PRAIRIE ISLAND NUCLEAR GENERATING PLANT

REQUEST FOR AMENDMENT TO
OPERATING LICENSE NOS. DPR-42 & DPR-60

(License Amendment Request Dated January 13, 1984)

Specification: Reactor Coolant Vent System - TS 3.1/4.18

Figure 1

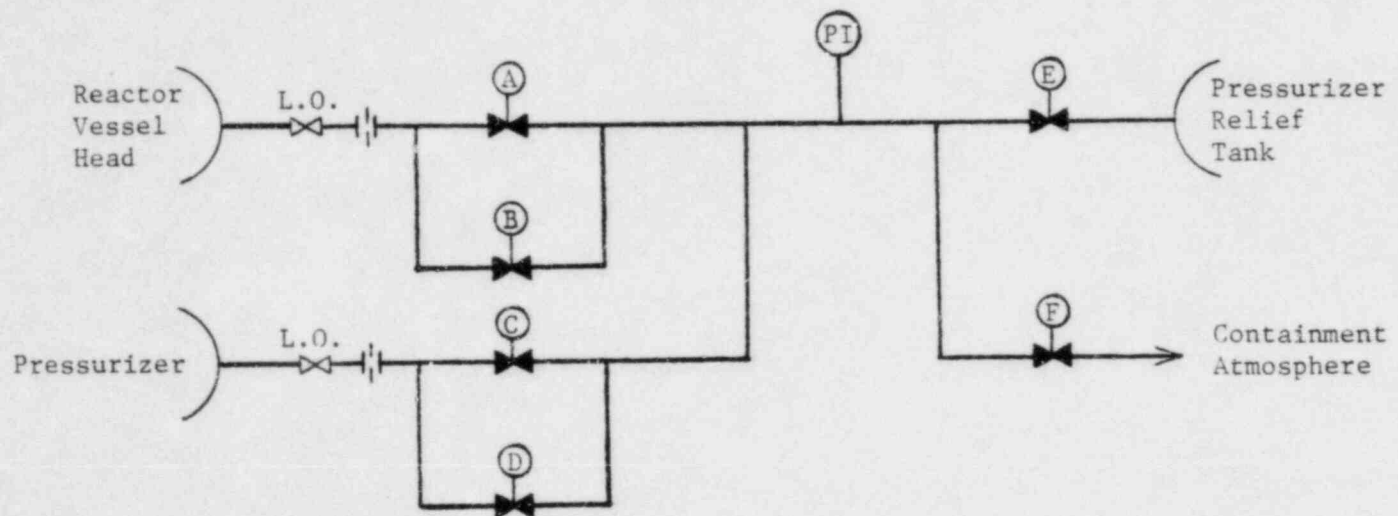
- 1) A flow restriction orifice in each vent path limits the vent system flow to less than the flow of the reactor coolant makeup system.
 - 2) Pressure indication is provided to the control room (see Figure 1) to enable the operator to recognize any discharge of reactor coolant through the vent system.

The actions required by various vent system conditions are summarized in Figure 1 of Exhibit A. The proposed Limiting Conditions for Operation and required actions, in combination with the redundancy in the system design, provide adequate assurance that the capability to exhaust noncondensable gases from the reactor coolant system will exist should it become necessary.
